TO: US and Canada Dealer Principals, Service Managers, Parts Managers and Sales Managers
RE: Recall R157 Volvo XC90 (MY2003 – MY2006) Outer Tie Rod End May Fracture

<h1>VOLVO</h1> <h2>Service Manager Bulletin</h2>				TITLE: Recall 157 Outer Tie Rod End May Fracture		GROUP: 64	NO: 157
				MODEL YEAR 2003-2006 XC90		ISSUING DEPARTMENT: Warranty	
				REFERENCE BULLETINS: TNN# 64-157 PB# 64-157 Supersedes: SMB 64-157 dated 2006-05-31		CAR MARKET: United States, Canada	
						DATE: YEAR MONTH DAY 2006 07 21	
Service Personnel: read and initial.	SERVICE MANAGER	SERVICE WRITER	WARRANTY ADMINISTRATOR	Page 1 of 3

SUBJECT: Recall 157 Outer Tie Rod End May Fracture.
REFERENCE: VIDA, SMB 64-157, PB 64-157

Installing the outer tie rod

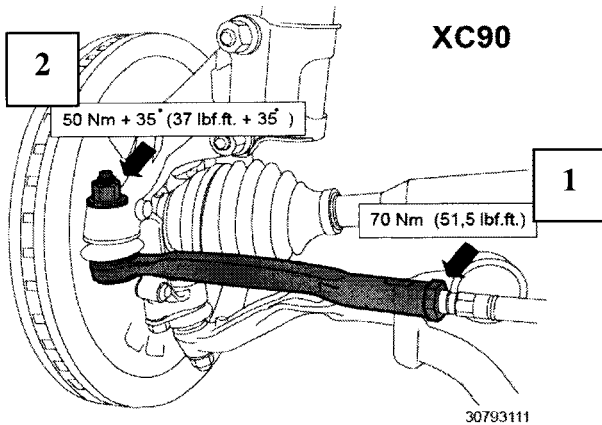
Note! It is critical that the proper torque is achieved when installing the outer tie rods; only hand tools may be used. Do not use impact tools when installing the outer tie rod!

Note: Current replacement instructions in VIDA have incorrect tightening information.

- the outer tie rod on the steering gear **1**. Torque the jam nut to 70 Nm (51.5 ft/lb).
 - The outer tie rod on the wheel spindle **2**. Use a wrench to counterhold the shaft, and tighten to 50 Nm + angle torque to 35° (37 ft/lb + angle torque to 35°).
-
-

Note! It is critical that the proper torque is achieved when installing the outer tie rods; **only hand tools may be used.** Do not use impact tools when installing the outer tie rod!

Installing the outer tie rod

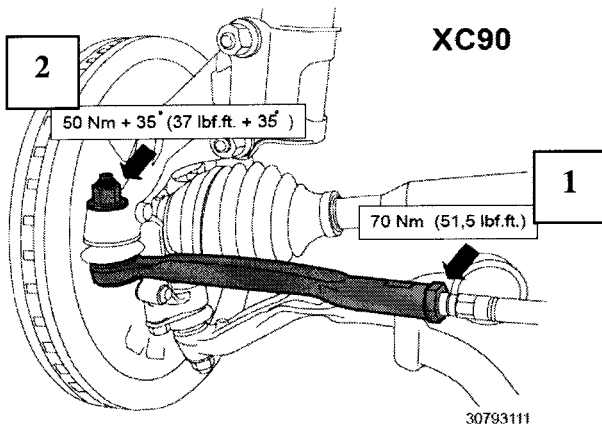
Note! It is critical that the proper torque is achieved when installing the outer tie rods; only hand tools may be used. Do not use impact tools when installing the outer tie rod!

Note: Current replacement instructions in VIDA have incorrect tightening information.

- the outer tie rod on the steering gear **1**. Torque the jam nut to 70 Nm (51.5 ft/lb).
 - The outer tie rod on the wheel spindle **2**. Use a wrench to counterhold the shaft, and tighten to 50 Nm + angle torque to 35° (37 ft/lb + angle torque to 35°).
-
-

Note! It is critical that the proper torque is achieved when installing the outer tie rods; **only hand tools may be used.** Do not use impact tools when installing the outer tie rod!
